**MONTGOMERY COUNTY HISTORIC PRESERVATION COMMISSION**  
**STAFF REPORT**

<b>Address:</b>	15 W. Lenox Street, Chevy Chase	<b>Meeting Date:</b>	10/9/2024
<b>Resource:</b>	Contributing Resource <b>Chevy Chase Village Historic District</b>	<b>Report Date:</b>	10/2/2024
<b>Applicant:</b>	15 W. Lenox Trust Amber Phaire	<b>Public Notice:</b>	9/25/2024
<b>Review:</b>	Historic Area Work Permit	<b>Tax Credit:</b>	n/a
<b>Case Number:</b>	1085874	<b>Staff:</b>	Dan Bruechert
<b>Proposal:</b>	Fence Installation

**STAFF RECOMMENDATION**

**Figure 2: Design of the proposed fence.**

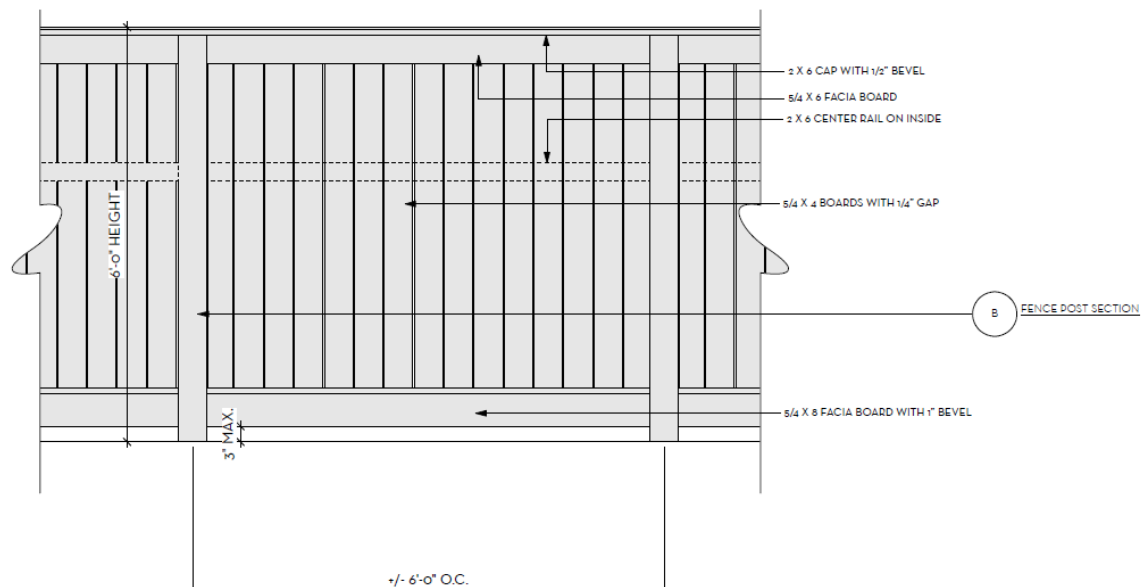
The proposed fence should be reviewed under moderate scrutiny as it would be visible from the public right-of-way when viewed in the absence of vegetation. Staff finds the design and materials of the proposed fence (see Fig. 2, below) are compatible with the character of the site and surrounding district.

Figure 3: The southeast corner of the subject property. The area of Staff's recommended condition is shown in blue.

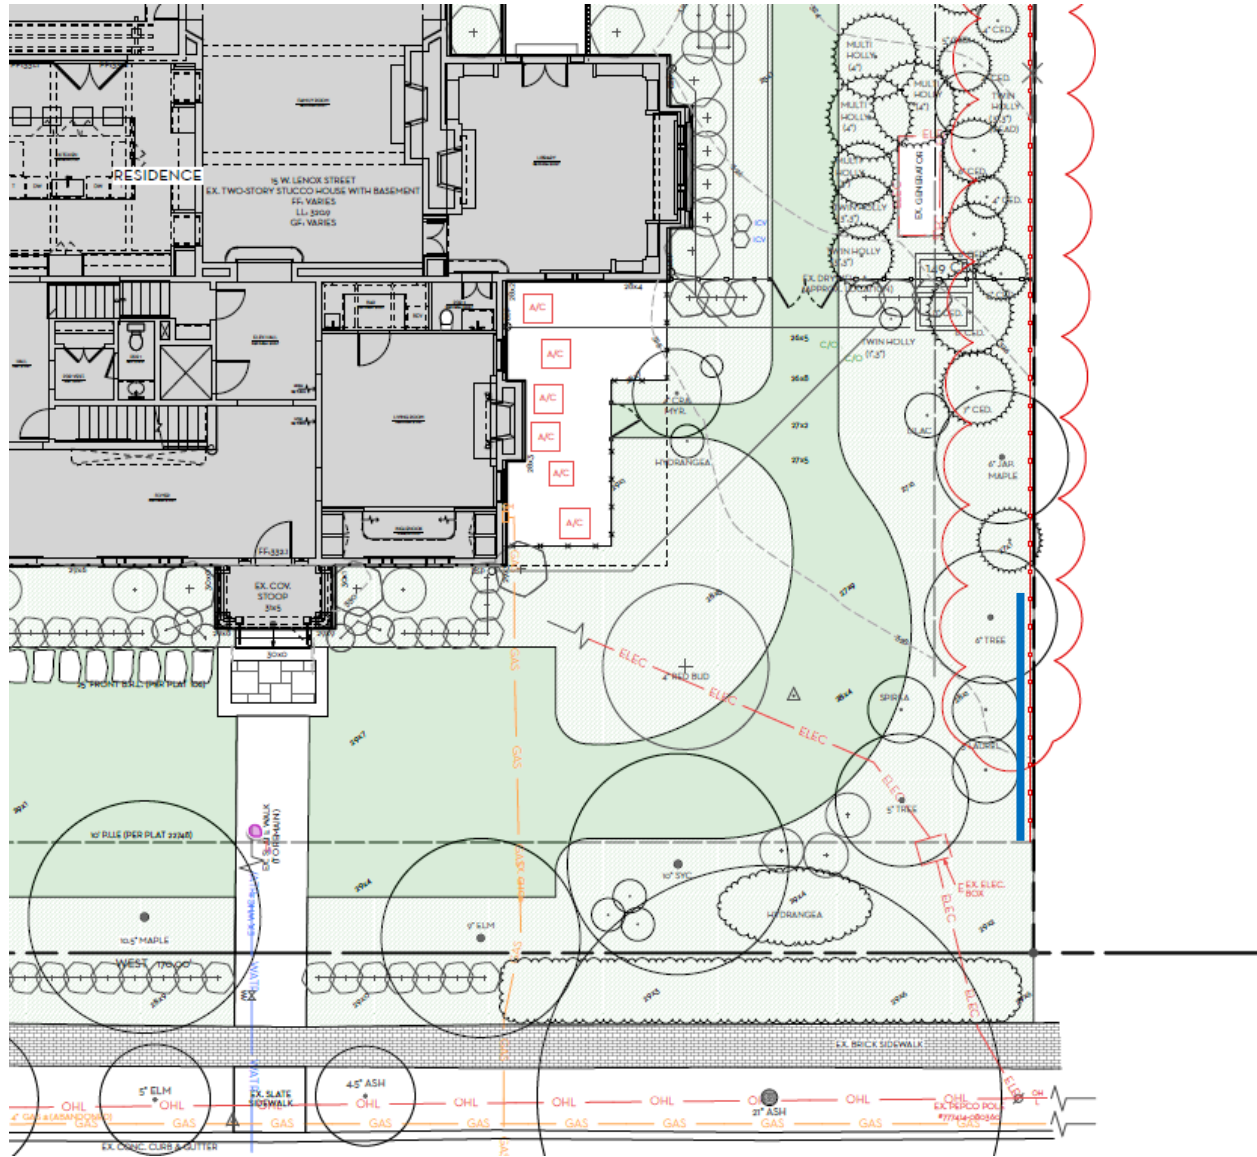
However, Staff does not find the height of the proposed fence is compatible with the character of the site and it will detract from the district's "open, park-like setting" as proposed. The typical requirement for fences in the Chevy Chase Village Historic District is that fences forward of the historic rear wall plane be no taller than 4' (four feet) and generally have an open picket design. In this instance, Staff finds that because the lot slopes away from street grade, much of the fence will appear lower than 4' (four feet). Additionally, because the fence will appear lower than 4' (four feet), people will be able to look over the fence when viewed from the public right-of-way, which largely eliminates the need for an open picket design to retain the openness sought after in the *Design Guidelines*. However, Staff finds the area to the front of the front wall plan should be no taller than 4' (four feet) and recommends the HPC include a condition to the approval of this HAWP to that effect. The area in front of the front wall plane is approximately 2' (two feet) below street-grade and a 6' (six foot) solid board fence is insufficient to retain the district's open park-like setting. Staff finds that either a 4' (four foot) tall fence of a variety of designs would be appropriate. Final plans satisfying this condition would need to be submitted to Staff to verify

1. The fence forward of the front wall plane of the house must be no taller than 4' (four feet).
